JOSEPH M. FARLEY NUCLEAR PLANT - UNIT 2
CONTAINMENT PURGE SYSTEM

ENCLOSURE 1

QUESTION 020.1:

FIGURE 1

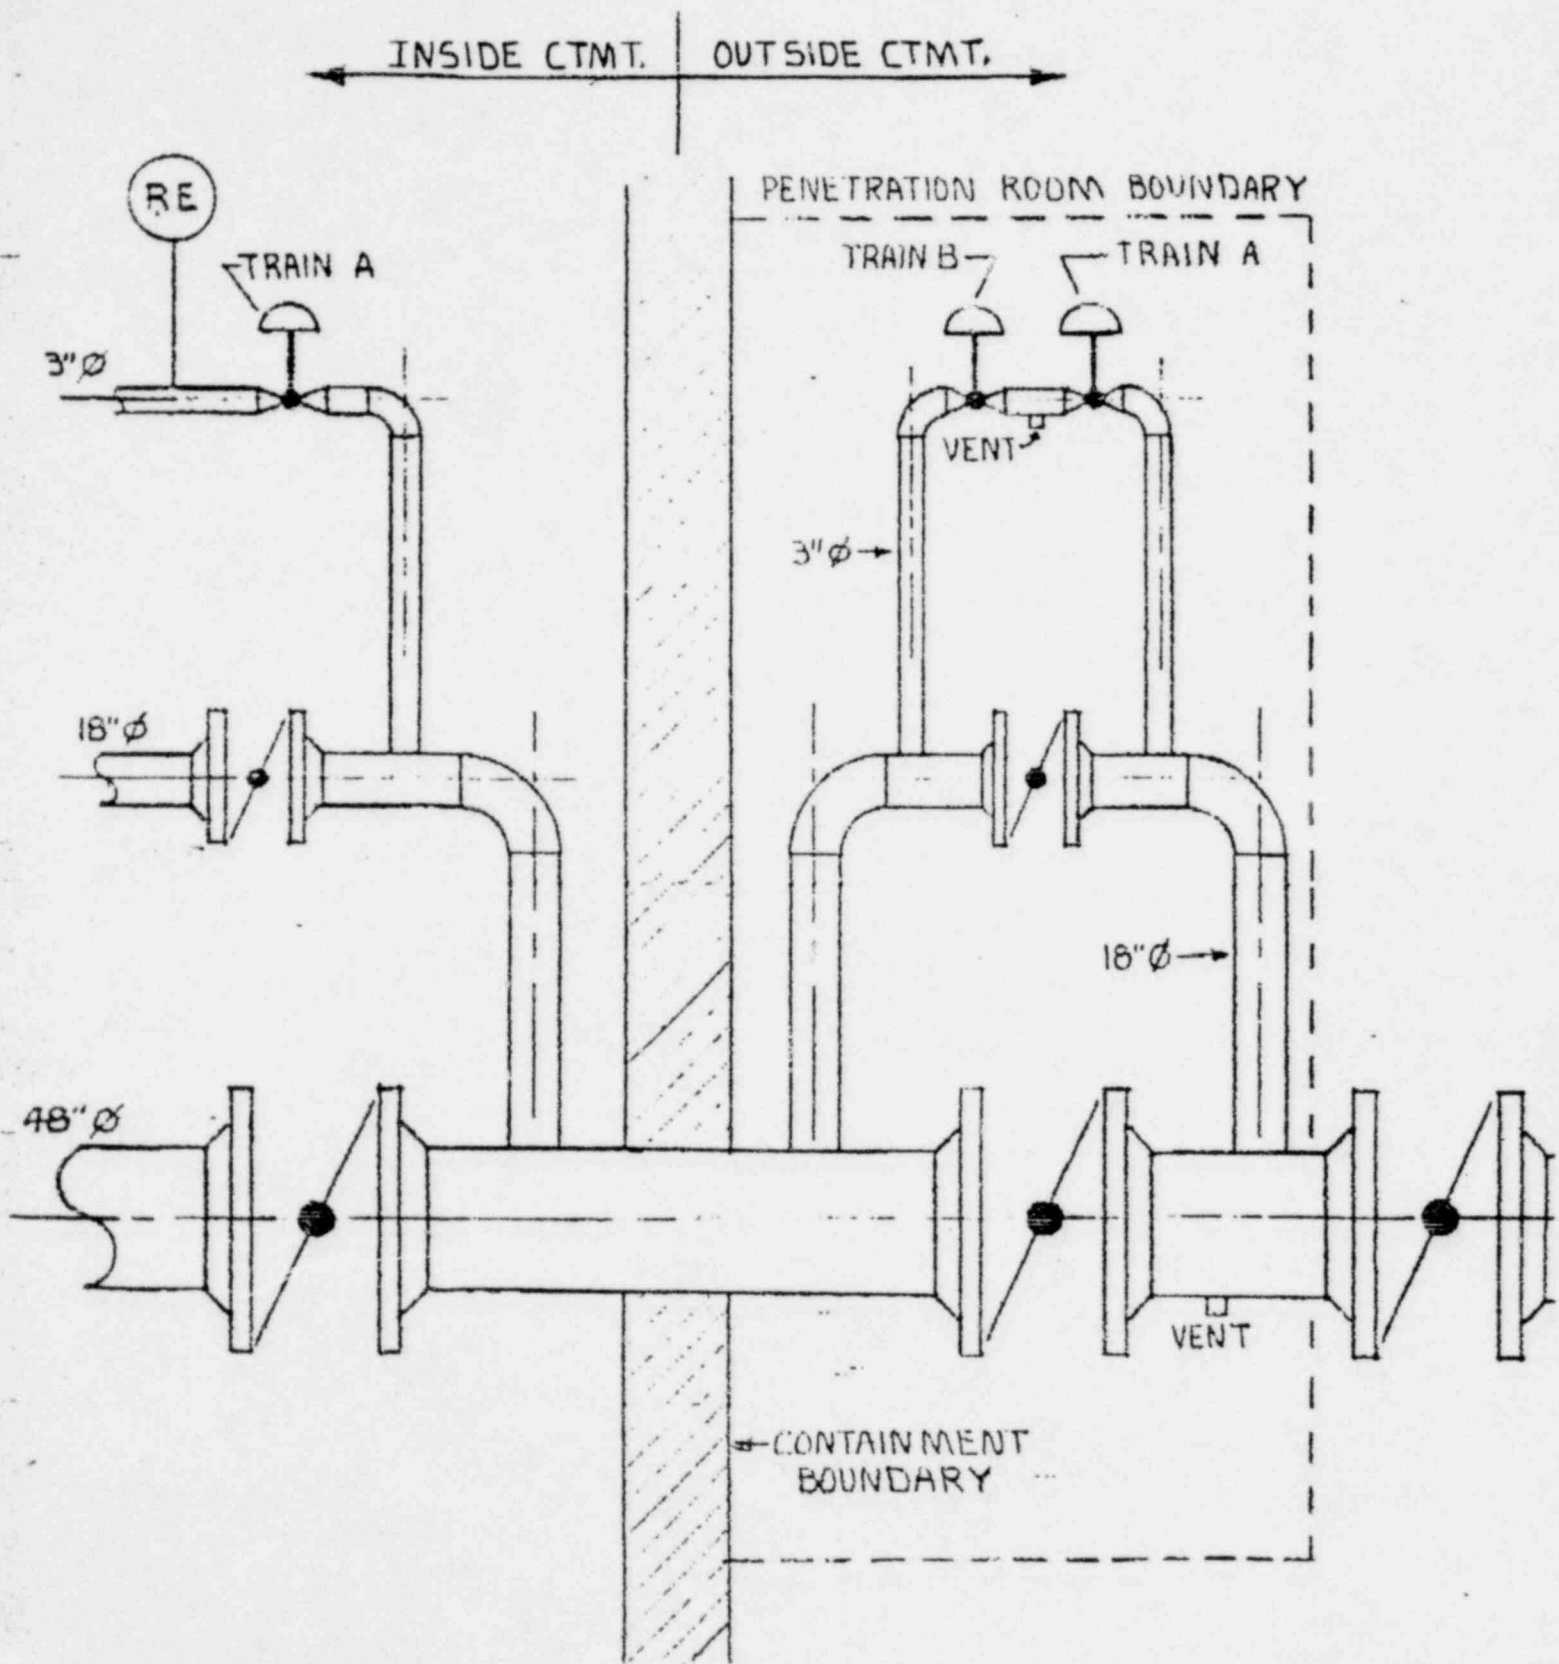
Alabama Power Company therefore proposes to install a 3-inch vent line in parallel with the 18-inch mini-purge system by the end of the first refueling outage. The 3-inch line size was selected based on Alabama Power Company's understanding of the modified NRC Branch Technical Position CSB 6-4, yet to be revised. The new 3-inch air operated containment isolation valves will be fully qualified to their intended use. They will be powered and controlled by the same sources and signals which are currently used for the 18-inch mini-purge valves. The lead time for these valves is at least 12 months. This proposed design is shown in the attached Figure (1). The 3-inch gate or globe type isolation valves will be automatic air operated valves set to close on any of the following signals:

The valves will be periodically opened, allowing the containment to vent. This design will prevent containment pressurization while still allowing a more than adequate isolation capability. A small vent between the two outboard isolation valves will assure that any leakage past these containment isolation valves will be drawn into the containment penetration room filtration system. This alternative has been chosen for the Farley Nuclear Plant after consideration of such factors as valve operability and feasibility of piping design changes and other additions required.
